PRE-APPLICATION CONFERENCE NOTES

Project Name: The Views PD

**PLANNING COMMISSION STAFF REPORT
TYPE IV RECOMMENDATION TO THE CITY COUNCIL**

Additional PD Code Deviation Requests

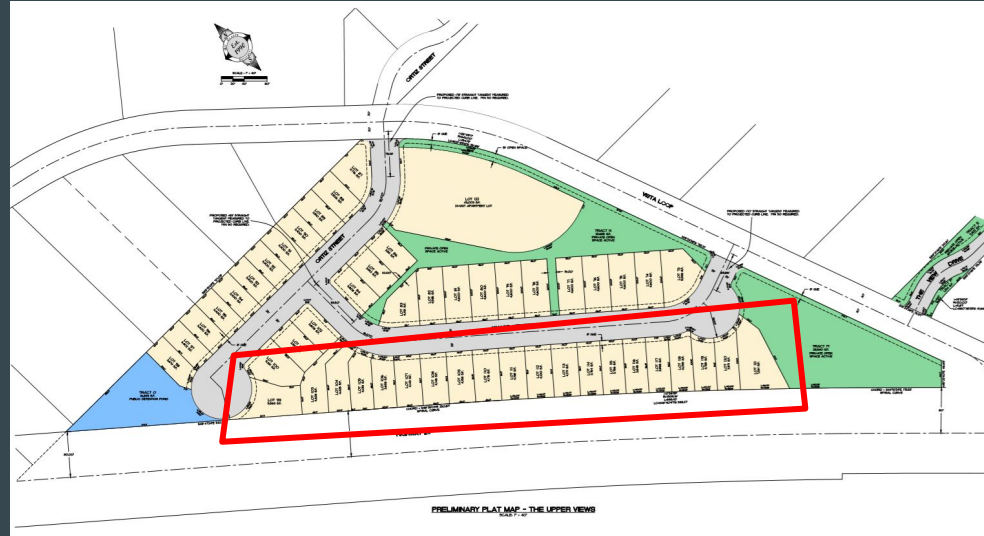
- Rowhouses and multi-family housing
- Smaller lot sizes
- Smaller minimum average lot width
- Smaller interior side yard setbacks
- Smaller rear yard setbacks
- Longer block lengths

Special Variances

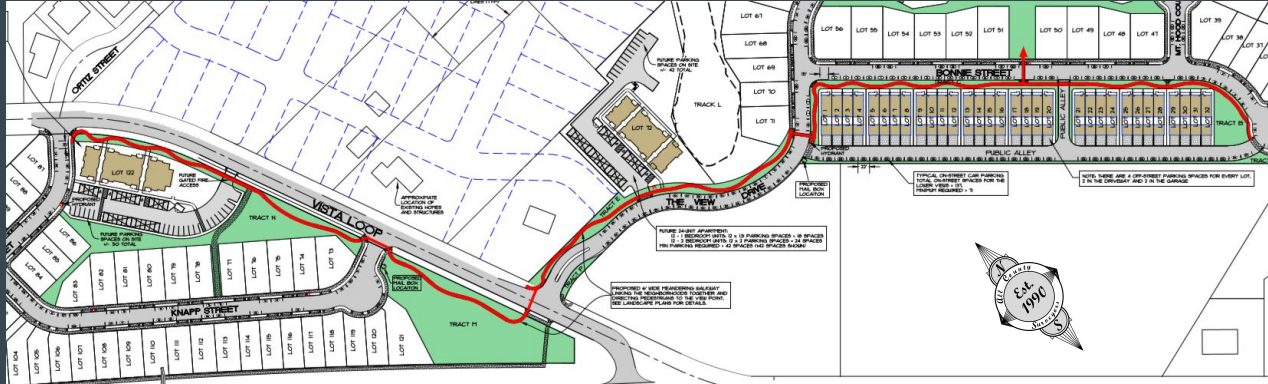
- SDC Section 17.84 requires sidewalks and planter strips along streets.
- The applicant is requesting to waive this requirement along the south side of The View Drive.
- The applicant is requesting to install a meandering walkway along Bonnie Street, The View Drive, and Vista Loop in lieu of sidewalks.

Additional PD Code Deviation Requests

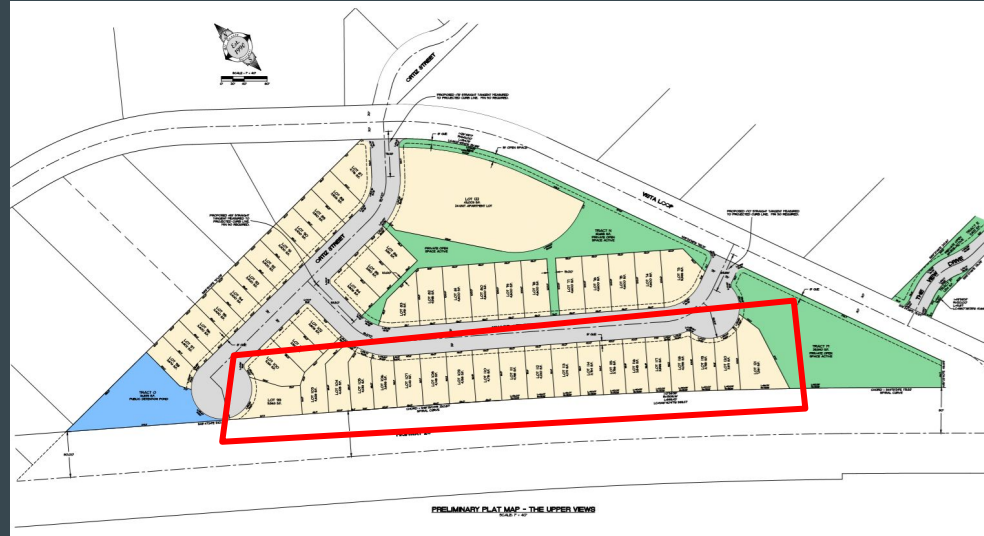
- Rowhouses and multi-family housing
- Smaller lot sizes
- Smaller minimum average lot width
- Smaller interior side yard setbacks
- Smaller rear yard setbacks
- Longer block lengths

Special Variances

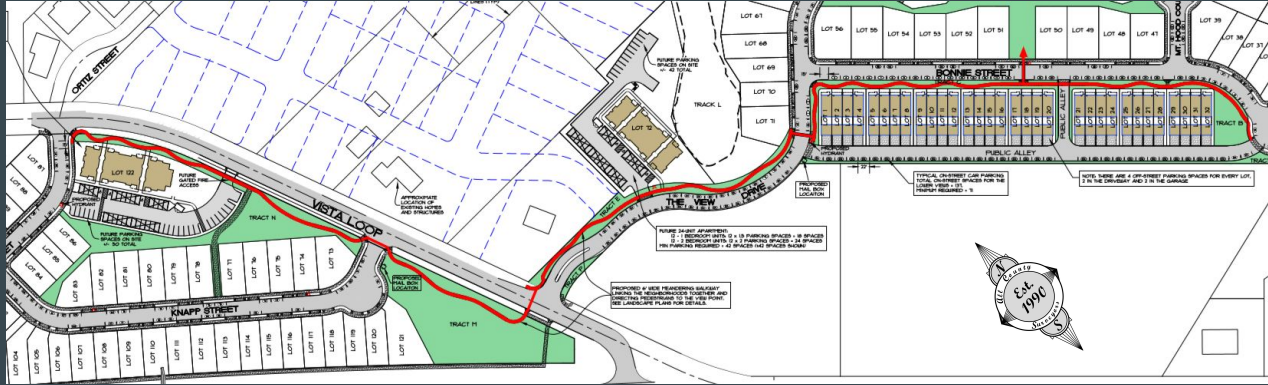
- SDC Section 17.84 requires sidewalks and planter strips along streets.
- The applicant is requesting to waive this requirement along the south side of The View Drive.
- The applicant is requesting to install a meandering walkway along Bonnie Street, the north side of The View Drive, and Vista Loop in lieu of sidewalks.
